# **US-APWR DCD Revision 4 Tracking Report**

**March 2014**

## **General Description**

This report includes a table that identifies the impact of each response to the Request for Additional Information (“RAI”) relative to the Design Control Document (“DCD”) Revision 4 of US-APWR. This table denotes the RAI responses which have been submitted from June 29, 2013 through February 28, 2014 that have been incorporated into this Tracking Report using red text.

Figure 7.1-1 US-APWR I&C Overall Architecture

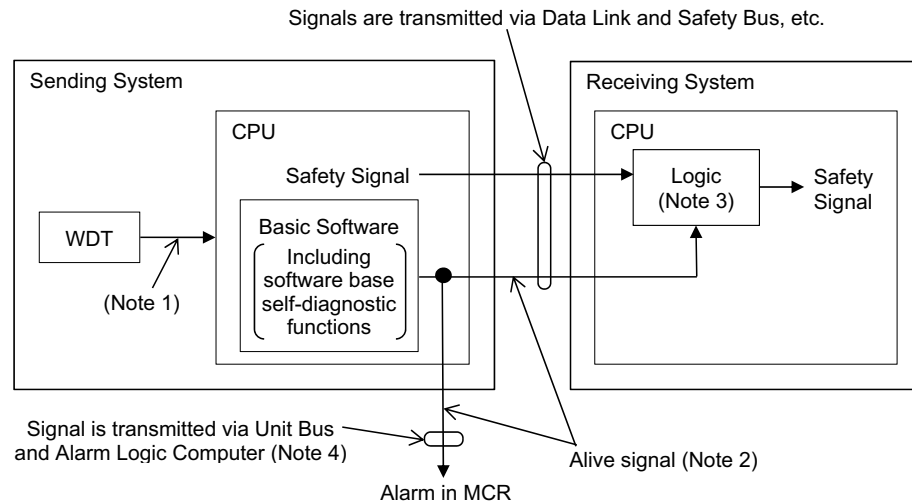
MIC-04-07-00003

MIC-04-07-  
00001

Figure 7.3-1 Configuration of Engineered Safety Features Actuation System and Safety Logic System

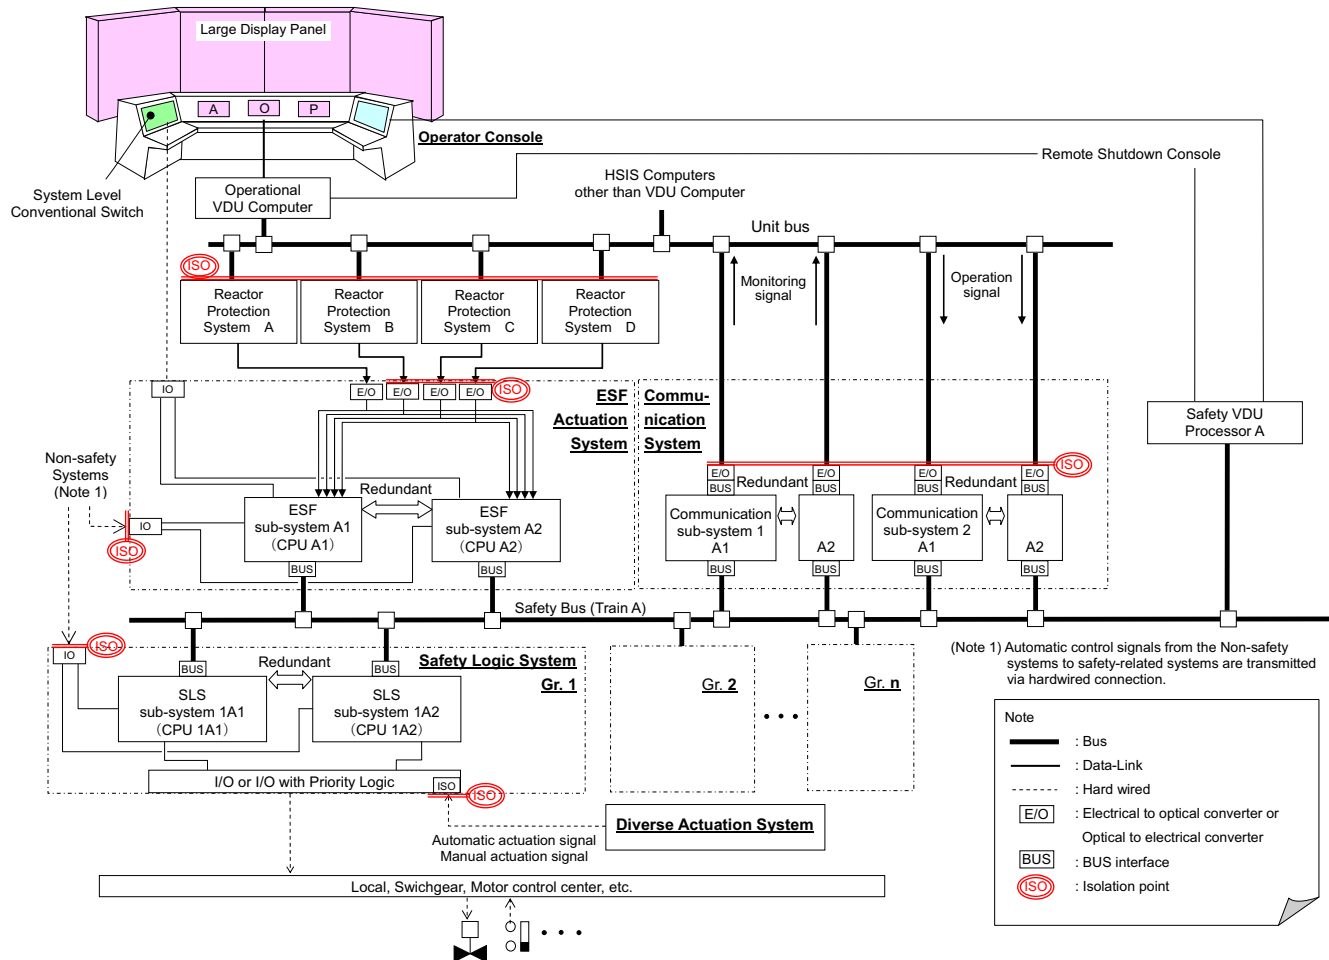
MIC-04-07-  
00001

MIC-04-07-  
00001

Figure 7.5-4 Alarm System Configuration

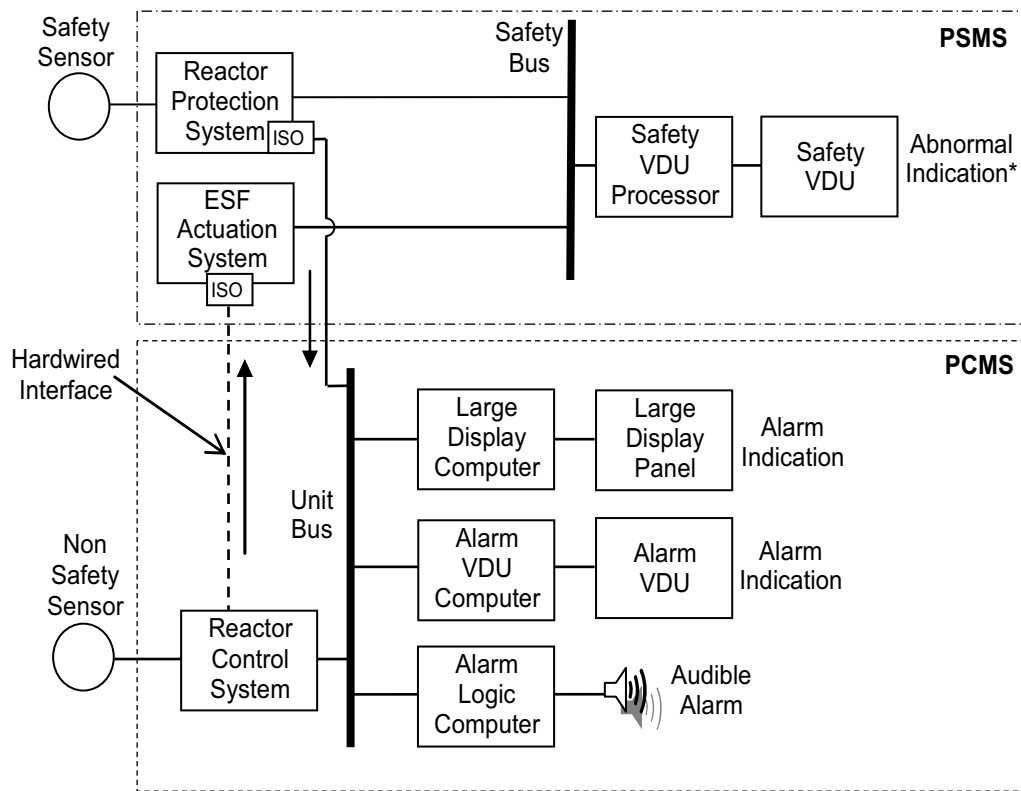
DCD\_07.05-  
18 S02

MIC-04-07-  
00001
